H. B. ROBINSON UNIT NO. 2

INSULATION AND PIPING AFFECTED BY FAILURE

OF "C" REACTOR COOLANT PUMP SEAL, MAY 2, 1975 FOLLOW-UP REPORT

This follow-up report is in response to questions raised by NRC regarding the initial report of June 13, 1975 on wetted insulation and lagging following the "C" reactor coolant pump seal failure. A summary of the piping and insulation inspections to be performed during the next refueling outage is also attached.

GRAPH 1

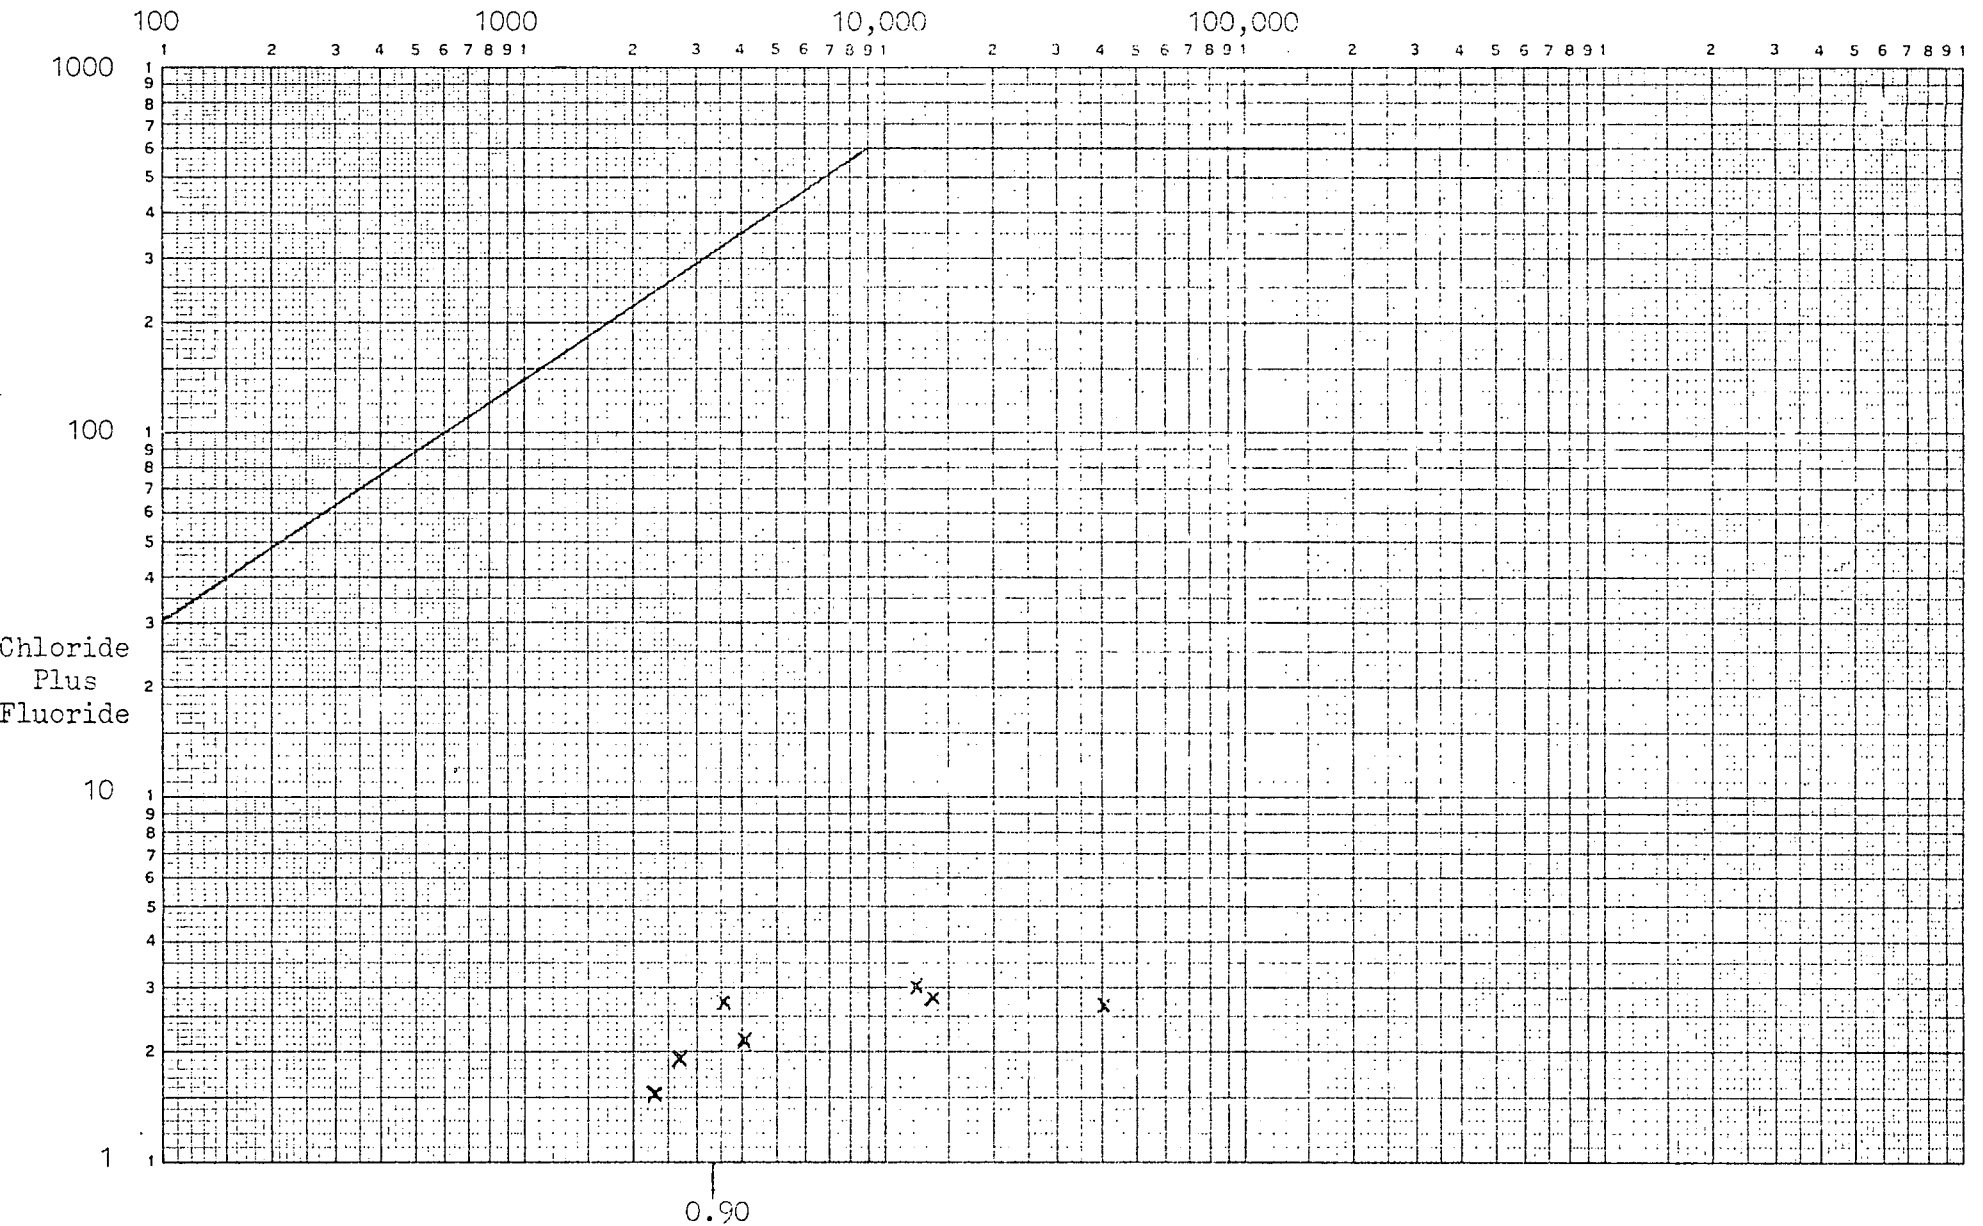
Data in Table 2 of the initial report does not coincide completely with data contained in Westinghouse Electric Corporation letter CPS-75-078 dated June 3, 1975.

Corrected plant data in Table II of CPS-75-078 is erroneous in at least three instances if Table I was used as basic data for conversion as stated.

Graphs 1 and 2 of Mr. Utley's letter do not specify units used for plotting the curves and respective data.

Corrected Tables I and II from the Westinghouse Electric Corporation letter CPS-75-078 of June 3, 1975 and Table 2 from the Carolina Power & Light Company letter of June 13, 1975 are enclosed. Also a corrected Graph 1 is included to correspond with the corrected data in the tables mentioned above.

The units (PPM) used for plotting the curves and respective data on Graphs 1 and 2 are the same as for Figure 1 shown in Regulatory Guide 1.36.

LINE DIAGRAM 3

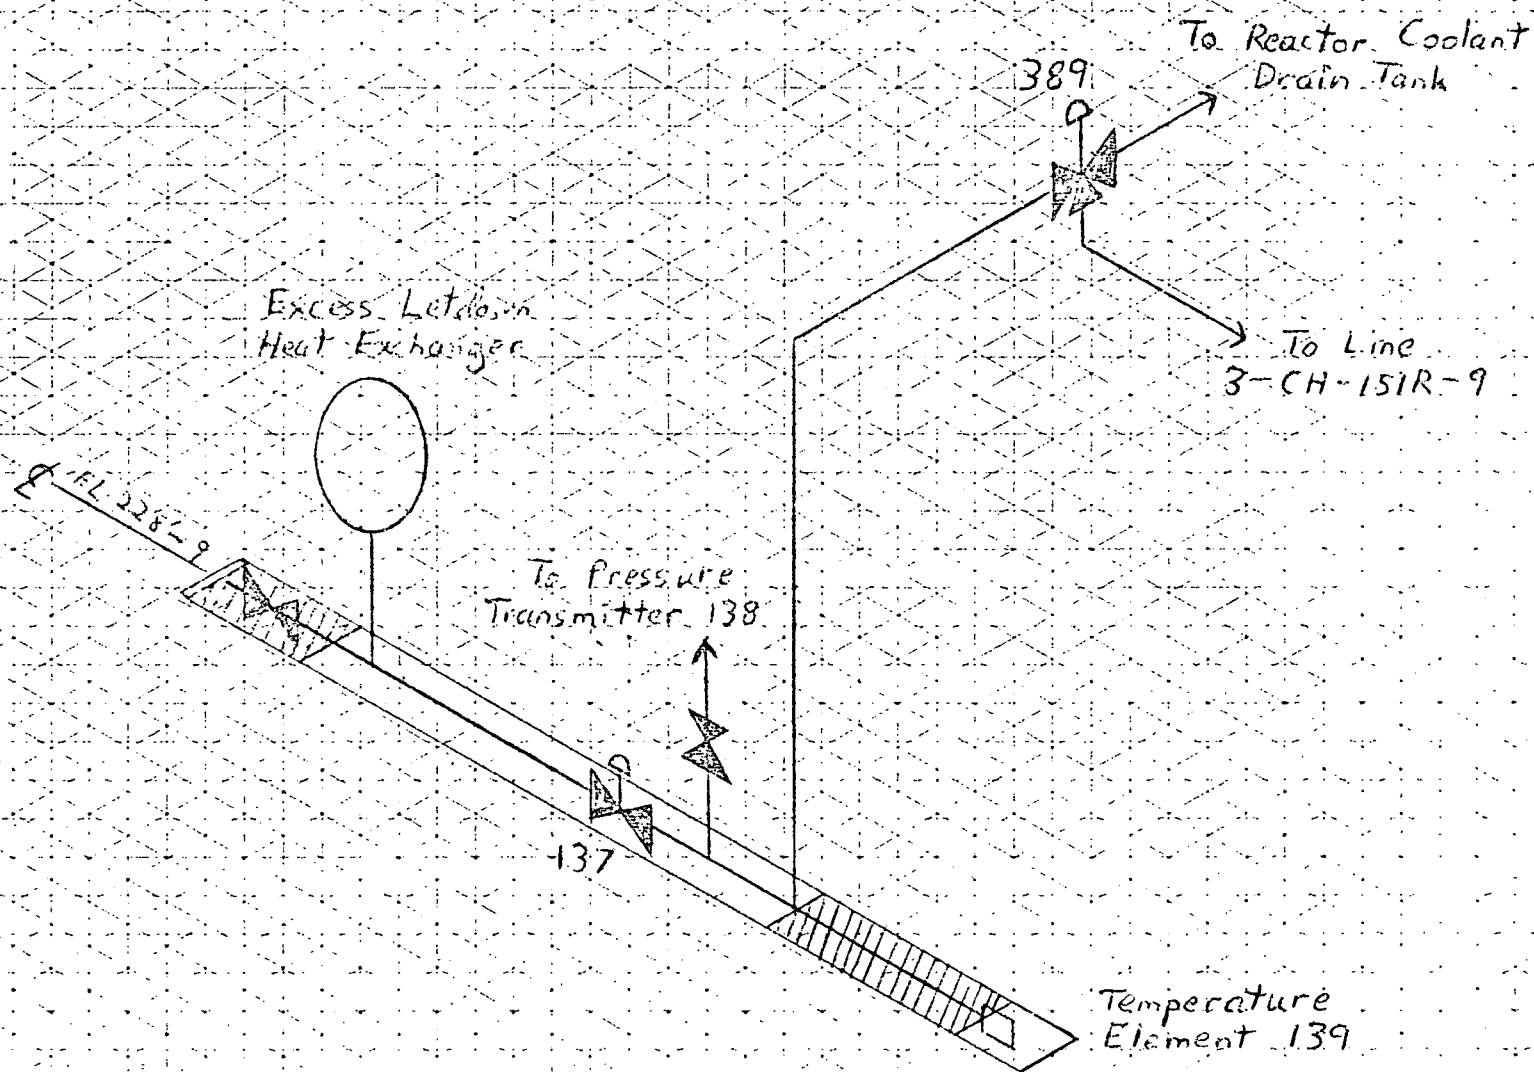
Charts showing the field location of the sampled piping insulation are illegible.

Drawings are attached which more clearly indicate the affected pipe and insulation.
